FILE P.I. # 122650-
EDS00-0072-00(039)
Elbert & Madison Counties
GDOT District 1 - Gainesville
SR 72 from West City Limits of Comer to East of
Broad River in Elbert

SUBJECT **APPROVED REVISED CONCEPT REPORT**

DEPARTMENT OF TRANSPORTATION
STATE OF GEORGIA
REVISED PROJECT CONCEPT REPORT

Project Number: EDS00-0072-00(039)
County: Madison/Elbert
P. I. Number: 122650
Federal Route Number: N/A
State Route Number: 72

TYPICAL SECTIONS
SR 72/COMER BYPASS

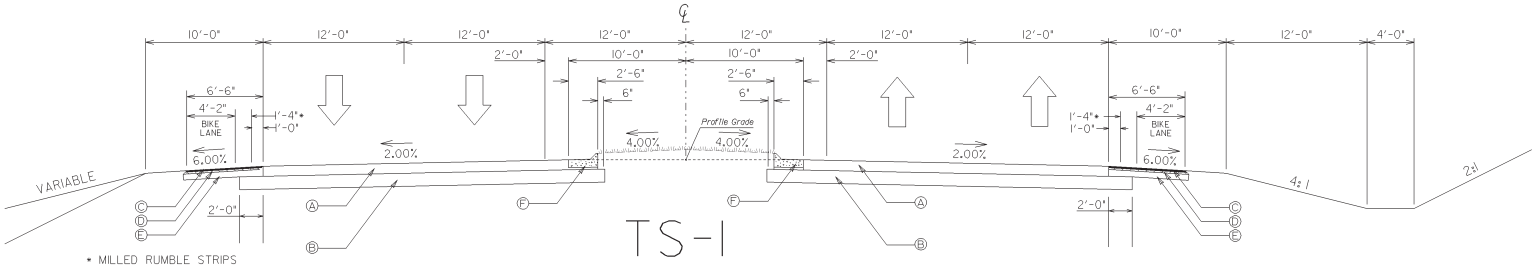
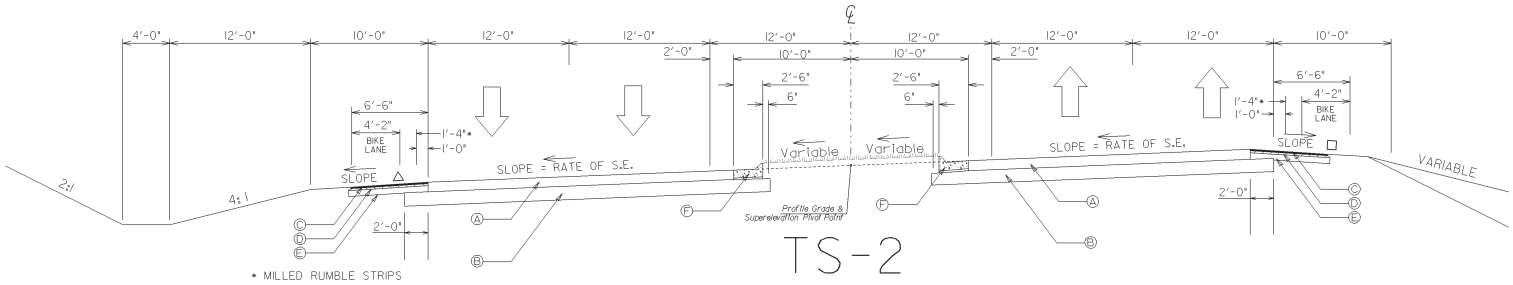
It is proposed that the median be revised from a 44-foot depressed to 24-foot raised for approximately the first 1.3 miles of the project. This reduction in median width will reduce ROW costs and impacts to the surrounding area. It is proposed to reduce the project length by approximately 0.25 miles. This reduction allows the tie in for existing SR 72 to be shifted onto PI 122100 to eliminate the need for a temporary tie in on that project.

Approved Features:	**Proposed Features:**
1. *MEDIAN WIDTH:* *Currently, a 44-foot depressed median is maintained throughout the project.* 2. *PROJECT LENGTH* *Currently, the western termini is located at the west Comer City limits, MP 9.79.*	1. *MEDIAN WIDTH:* *It is proposed that the median from the beginning of the project to approximately 1600 feet east of SR 98, MP 11.07, should be revised from a 44-foot depressed median to 24-foot raised median.* 2. *PROJECT LENGTH* *It is proposed that the project length be reduced approximately 0.25 miles, MP 10.04, to allow for the tie in for existing SR 72 to shift to PI 122100.*
Reason for Change: *To minimize the construction footprint, ROW impacts, and ROW costs it is recommended that the 44-foot depressed median proposed from the beginning of the project to 1600 feet east of SR 98 be reduced to a 24-foot raised median. If the project length is reduced, the tie in between proposed SR 72 and existing SR 72 located on PI 122650 can be shifted on to PI 122100. Transferring this tie in onto PI 122100 removes the need for a temporary tie in on that project, thus reducing the project's impact.*
